**ALTERATIONS AND ADDITIONS TO
STAR CITY CASINO COMPLEX,
PYRMONT & NEW HOTEL ON THE
SWITCHING STATION SITE**

MP 08_0098 (MOD 4)

Modification of Minister's Approval under section 75W
of the *Environmental Planning and Assessment Act*
1979

November 2009

Figure 2: Approved Pirrama Road façade

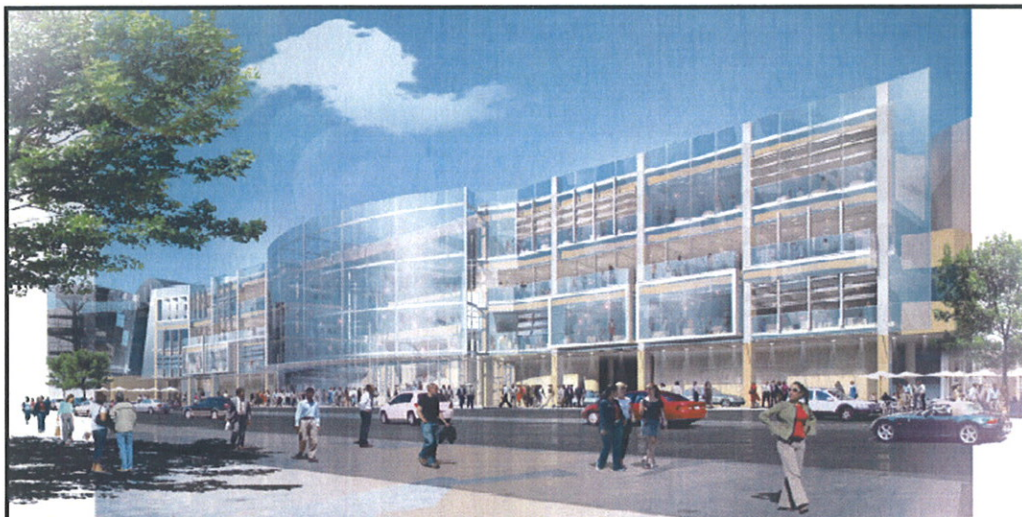
The proposed modifications (see **Figure 3**) are a further design response to issues raised by the Department and the DRP during the assessment of the original major project application in relation to:

- Providing a distinct central entry element where the curvilinear façade concaves at the front of the existing glass cupola element;
- Maintaining reference to the surrounding context by utilising sandstone coloured masonry walls at ground level;
- Removing the glazed façade on the ground floor which allows for greater integration with the public domain, visual connection and activation of the ground floor; and
- Providing open and fixed glass panels (see **Figure 4**) along the entire façade to provide greater interest and articulation.

The amended design removes the glazing at street level to reduce the dominance of glazing on the façade and does not extend the width of the façade. However, it is noted that on balance there is a minor increase in the level of glazing as the glazing removed from the ground floor is offset with additional panels on the balconies. The fixed open glass panels along Level 1 will ensure that

the façade will not present as a solid glazed wall from most view points. The small glass panels along the façade provides the building with a higher degree of transparency and reduced visual bulk. The Department's Senior Urban Design Specialist is also supportive of the modifications as they provide a generally more modern and refined design.

Council is generally supportive of the façade modification as the façade is considered to be more expressive and provides greater articulation. The Department considers that the amended design will allow for greater integration with the public domain and increased activation of the site. Accordingly, the Department considers the amended façade design is acceptable.

Figure 6: Proposed amended design - single porte cochere

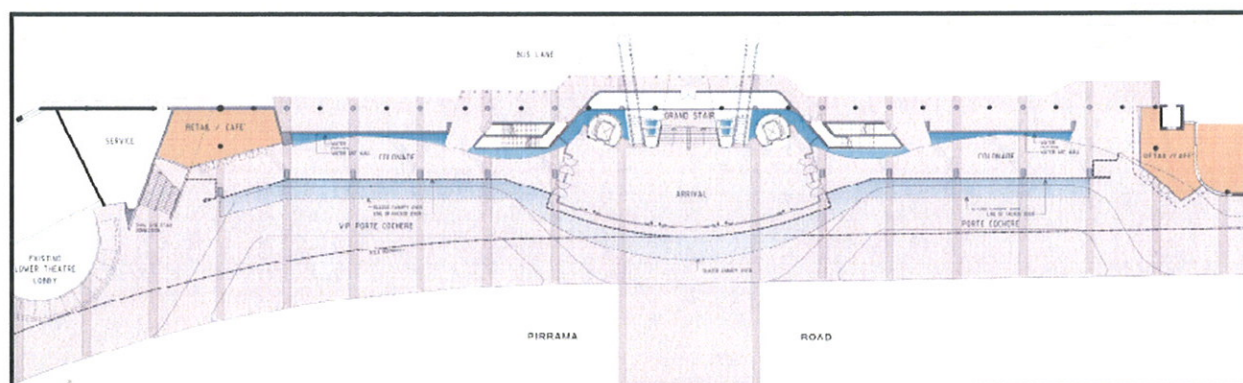
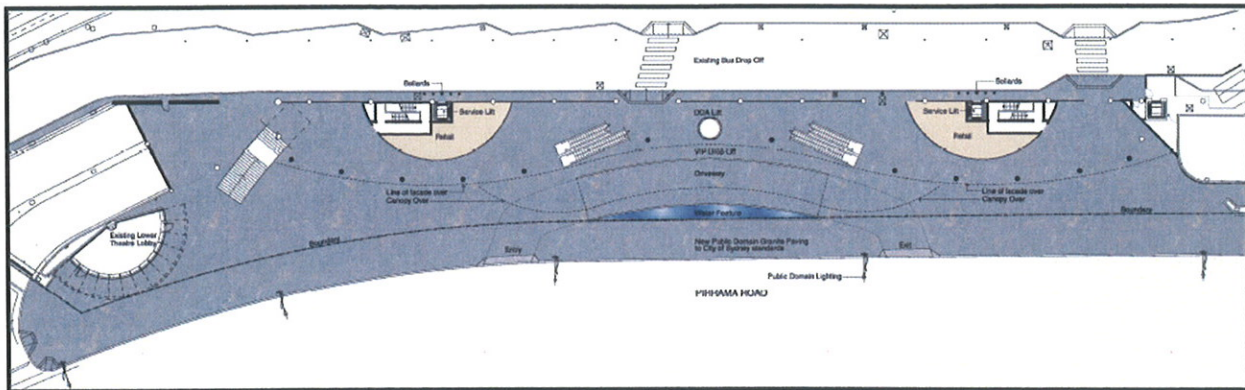
The proponent also seeks to consolidate the construction of two porte cocheres into a single porte cochere. The original major project application consisted of a single porte cochere which extended the length of the façade. The proponent amended the design to provide two porte cocheres (see **Figure 5**) in response to concerns raised by the Department and DRP during the assessment of the original major project application regarding the porte cochere's length and its deactivation of the public domain. The two porte cocheres were approved and the northern-most porte cochere was only permitted to be used during special events.

The proposed single porte cochere (see **Figure 6**), is a further design response to issues previously raised by the Department and the DRP, as outlined above. The porte cochere is a single porte cochere that is considerably shorter than that proposed in the original major project application, thereby allowing further activation of the public domain. The Department's Senior Urban Design Specialist is also supportive of the modifications as the public domain interface has been simplified. The deletion of the second porte cochere will also reduce pedestrian vehicle conflicts and improve pedestrian amenity.

The RTA did not raise any concerns regarding traffic impact and the proponent's traffic assessment confirms that the consolidation into one porte cochere will not have any adverse impact on traffic flows. Council is supportive of the design change as it removed the number of vehicle crossovers across the footpath resulting in improved pedestrian amenity. Council requested an additional condition be imposed regarding signage for porte cochere traffic movement. The proponent in their response to submissions has accepted the Council's proposed condition. The Department recommends an additional condition be imposed regarding Traffic Management Signage to ensure safe operation of the porte cochere and to protect pedestrian amenity.
